ADDENDUM - 01

SUBJECT:
RYEB Project #5301A
Salem City BOE
SALEM CITY HIGH SCHOOL
Roof top Exhaust Fan Replacement
DOE SP# 4630-050-08-1400

SK-M1
SCHS EXHAUST FAN REPLACEMENT
SALEM CITY BOE
10 SEPT 2010
 DRAWING REFERENCE M-101

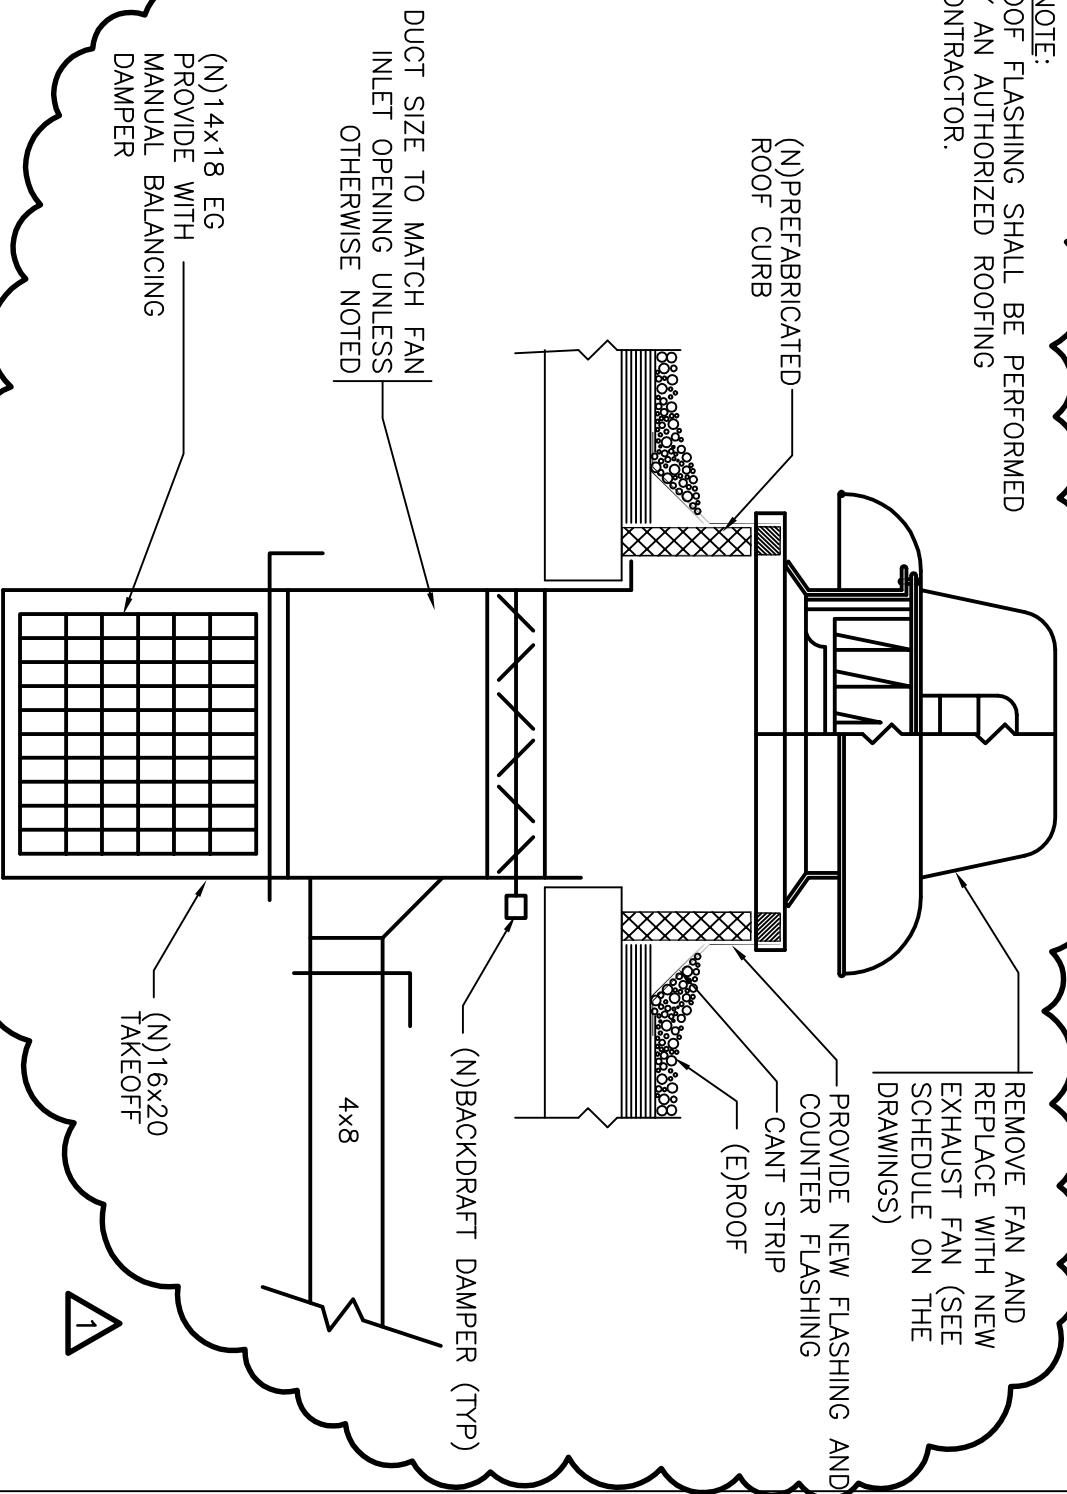
1.05 Drawing M101: Refer to sketch SK-M1 for modifications and clarifications to work associated with EF/A-2.

SK-M2
 SCHS EXHAUST FAN REPLACEMENT
 SALEM CITY BOE
 10 SEPT 2010

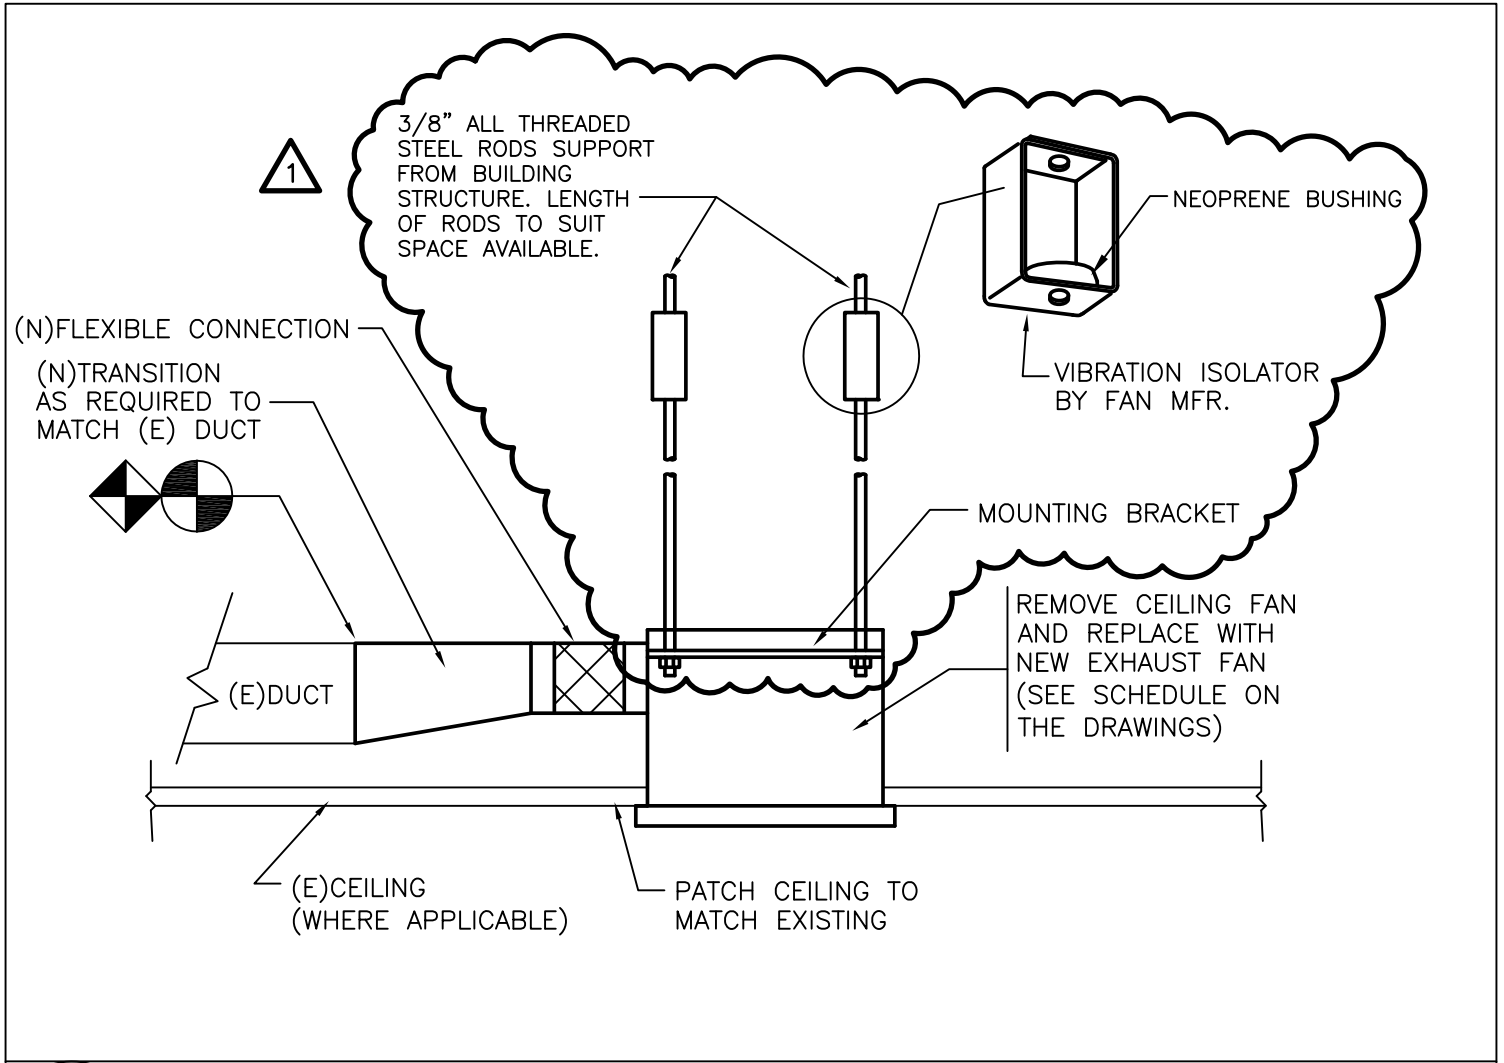
- a. Refer to sketch SK-M2 for modifications and clarifications to detail #3.
- b. Refer to sketch SK-M3 for modifications and clarifications to detail #4.
- c. Refer to sketch SK-M4 for modifications and clarifications to detail #5.
- d. The following changes are to be made to the Mechanical Schedule for the exhaust fans.

3 EXHAUST FAN A-2 DETAIL
 (MUSHROOM TYPE)
